COMMUNITY DEVELOPMENT DEPARTMENT REPORT

SUBJECT: H-2025-0041
Apex Zenith

LOCATION: Located at the southeast corner of Meridian Road and Lake Hazel Road in a portion of Lot 4 of Section 6, T.2N., R.1E.

Preliminary plat to subdivide two (2) existing parcels into seven (7) buildable lots across 11.065 acres of land in the C-G zoning district.

D. Landscape Plan (date: 8/27/2025)

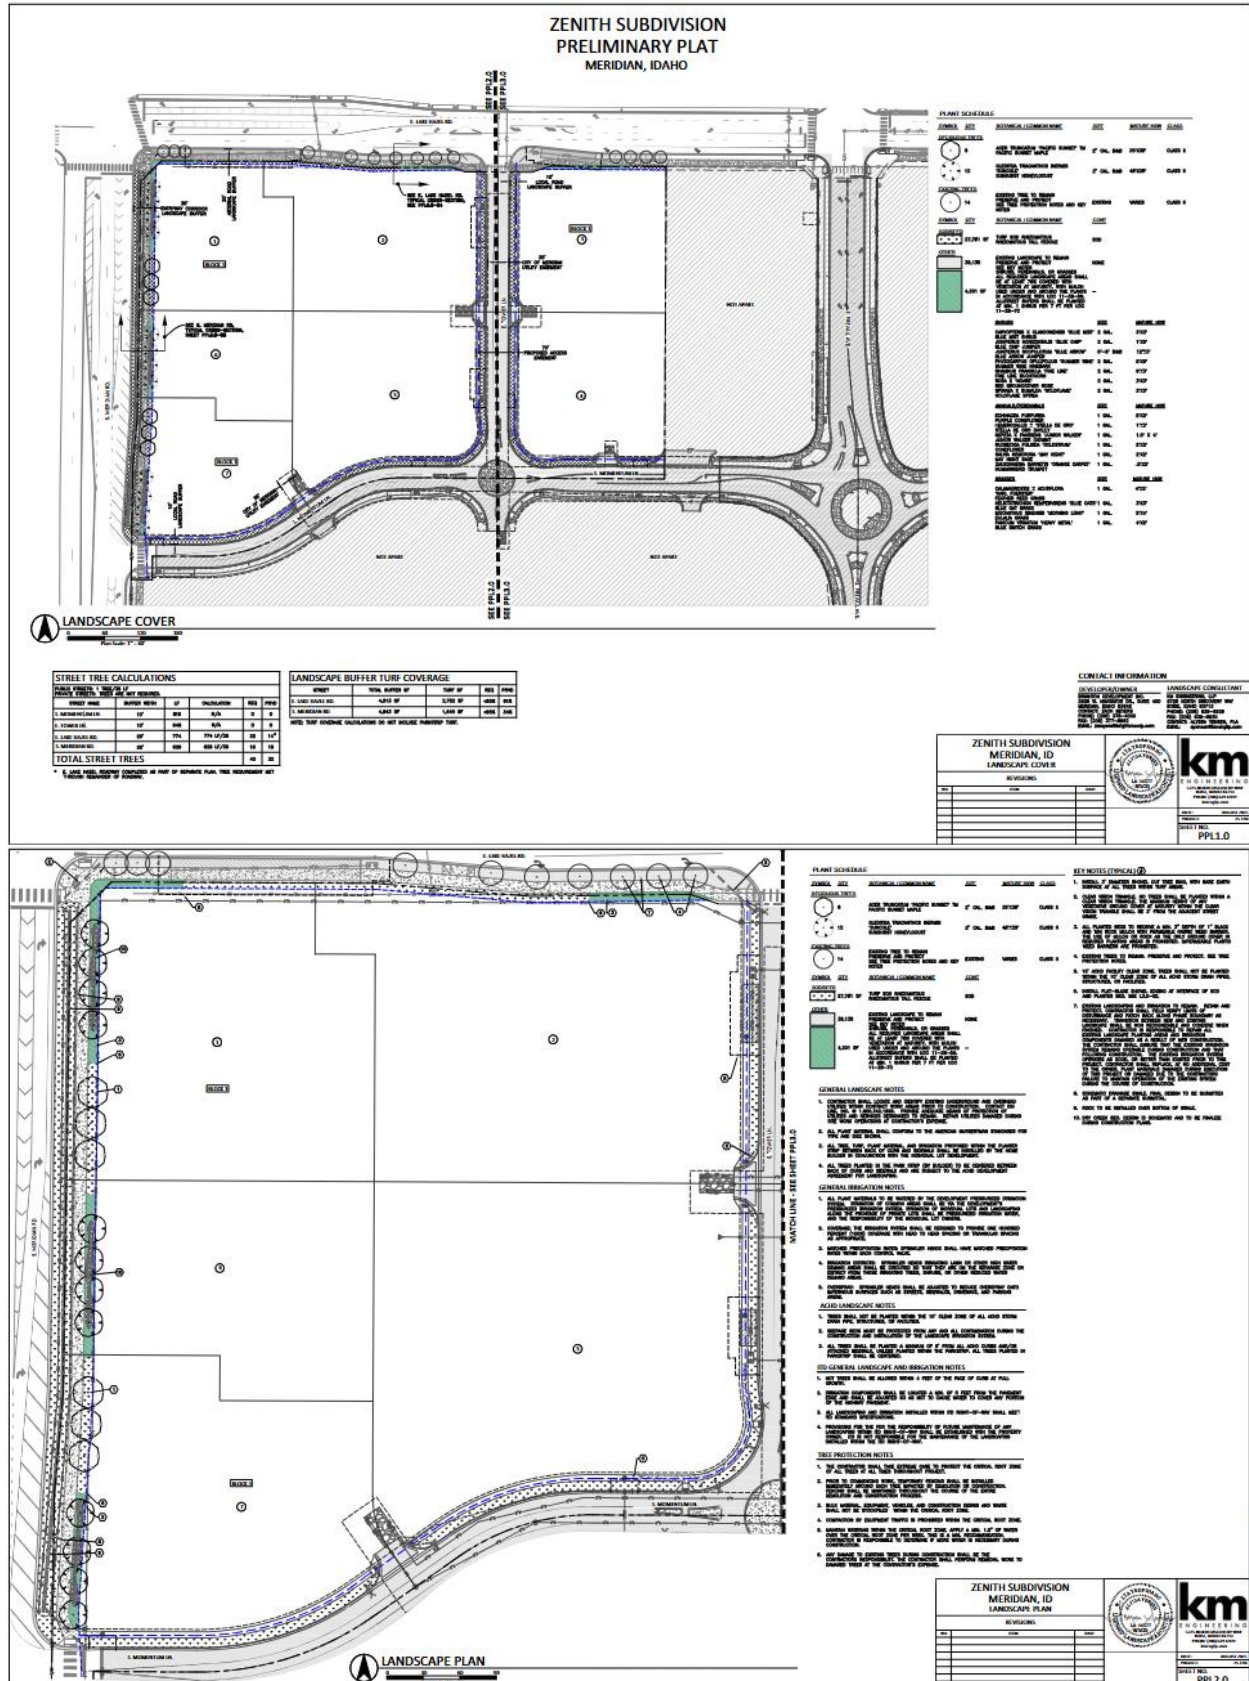
However, the preliminary plat shows a significant portion of the landscaping is proposed to be inside of the right of way. The applicant shall provide a license agreement with the transportation authority to certify the entire landscape buffer will meet UDC requirements. The buffers shall be outside of the proposed deceleration lanes and start at the back of the curb. Additional landscaping on each lot will be addressed with future certificate of zoning compliance applications.

6. Parkways (*Comp Plan, UDC 11-3A-17*):
UDC 11-3A-17 requires parkways of a minimum width of 8 feet. The applicant has indicated in their narrative that the parkways are 8 feet in width, however it is not dimensioned on the landscape plan. These parkways are provided along the private streets within the development alongside the five (5) foot sidewalks. The parkways shall be dimensioned and a minimum of 8 feet in width in the final plat application.

3. The final plat and landscape plan shall be revised as follows:
 - a. Provide the license agreement from ACHD and ITD for landscaping within the transportation authority's right of way.

- d. Revise the plat and landscape plans to include the dimensions of the pathways.
 - e. Depict landscaping along all pathways per the standards in UDC 11-3B-12C. A 5' wide landscape strip is required on both sides of the pathway planted with a *mix* of trees, shrubs, lawn and/or other vegetative ground cover.

E. Preliminary Plat (date: 9/18/2025)

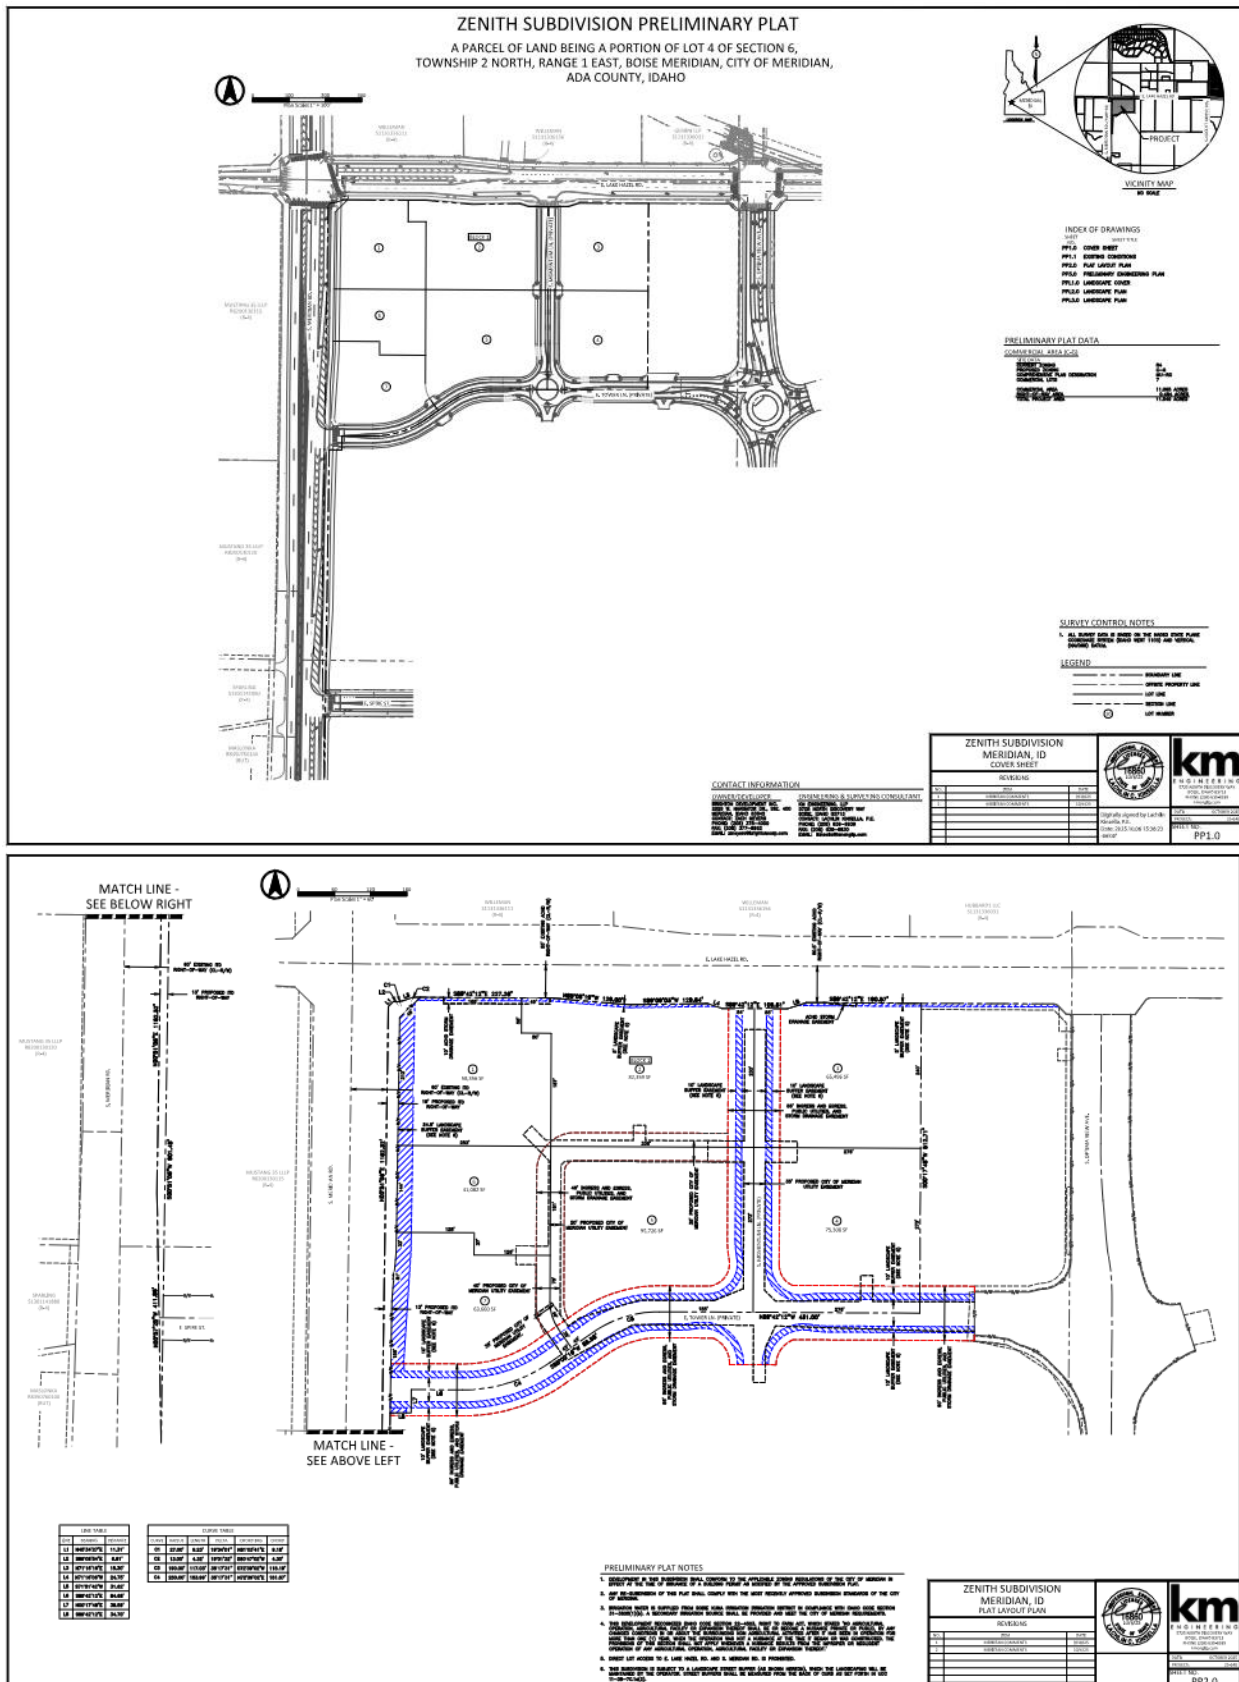
The applicant is depicting a second access along E. Tower Lane (private street) to Lot 4, Block 1; however, staff is recommending a shared access on the property line with the Costco Fuel Station (Parcel # S1406223040). The site plan on the Certificate of Zoning Compliance application (A-2025-0078) for Costco depicted an access point on the shared property line.

The applicant is showing two (2) access points to E. Tower Lane for Lot 4, Block 1 and the off-site property for the Costco Fuel Station. Staff is recommending these be consolidated into a single access point off of the private street due to limiting conflict points. The approved Costco CZC depicted a shared access point that was on the property line between proposed Lot 4, Block 1 and the Costco Fuel Facility.

4. Comply with all ACHD's staff report conditions of approval.
5. Use a shared access point between the Costco Fuel Station and Lot 4, Block 1 off E. Tower Lane as depicted on the CZC for Costco A-2025-0078.
